ADDENDUM NO. 3

Re: **CHPG# 2022-006**
Bennett Auditorium Renovations
University of Southern Mississippi
Hattiesburg, Mississippi

EXHIBIT "B"
 SHEET 1 OF 2

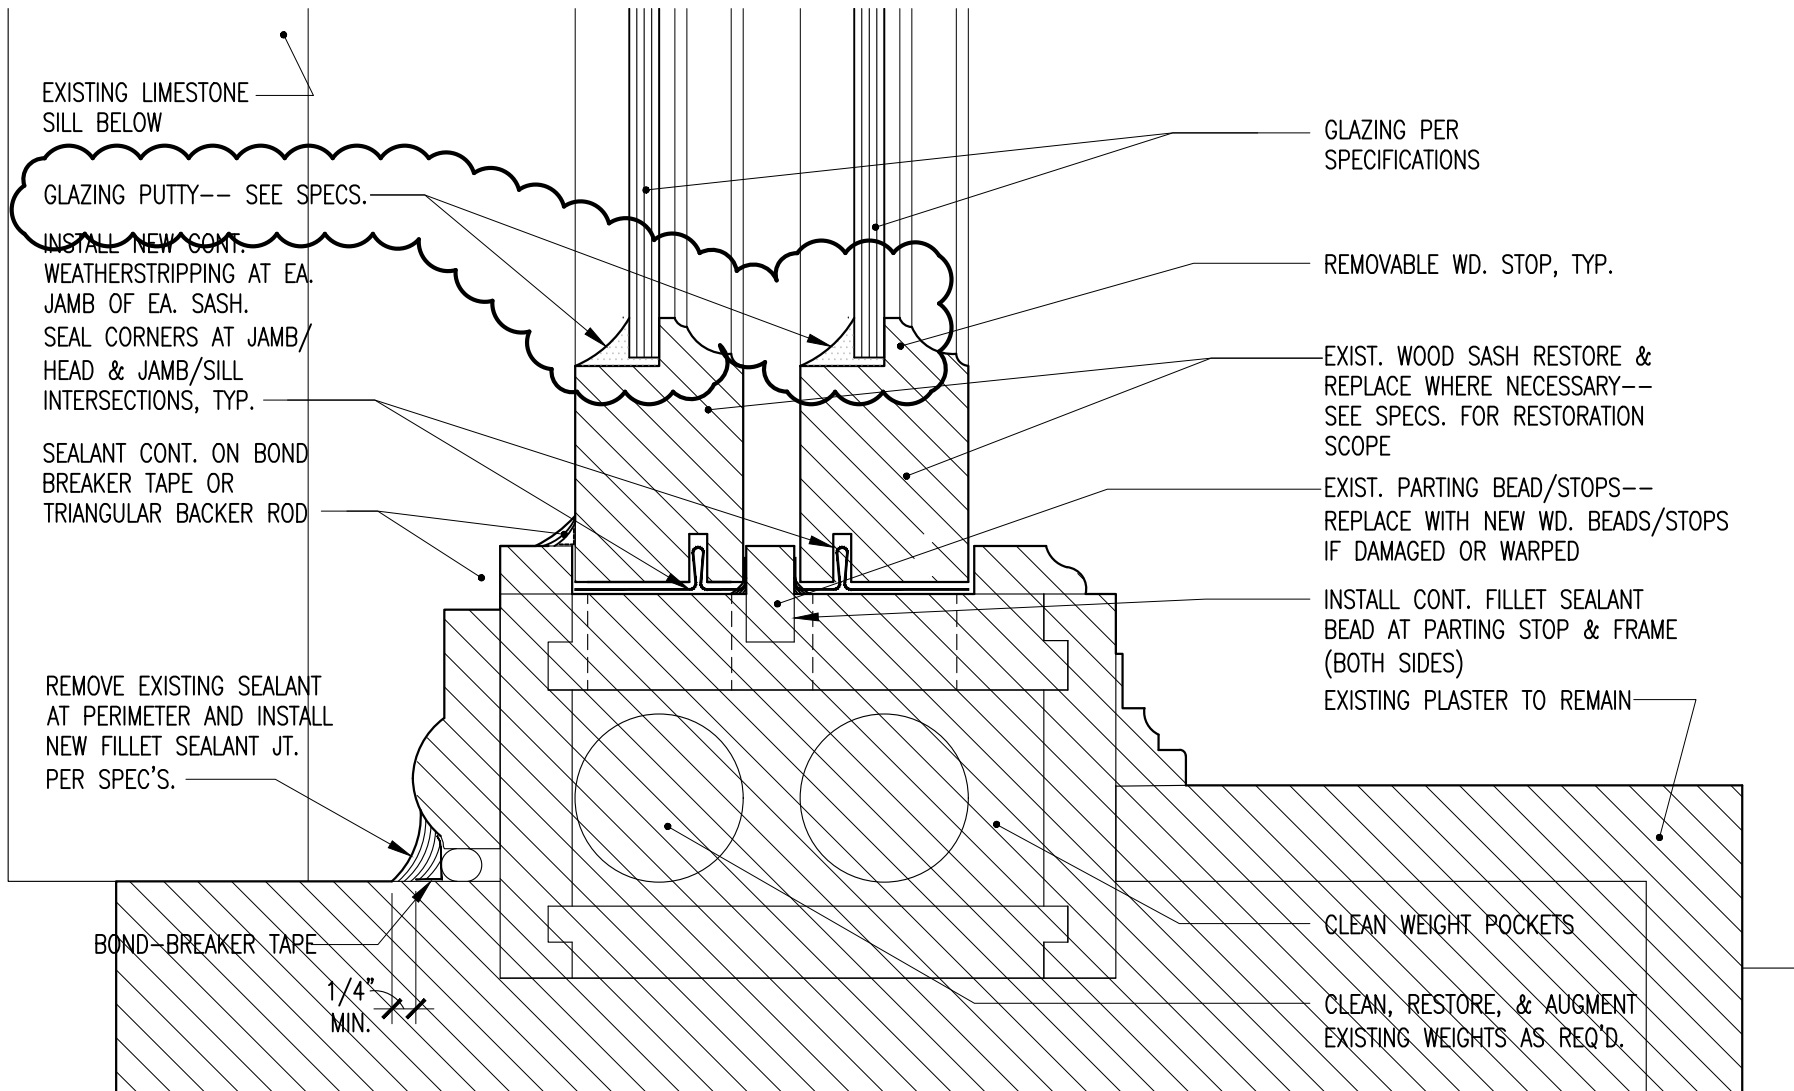
- Item No. 3** Refer to Sheet 2.0, typical window details, and clarify that all window details shall show exterior putty glazing, per attached revised example details "3" and "5". See Exhibit B.
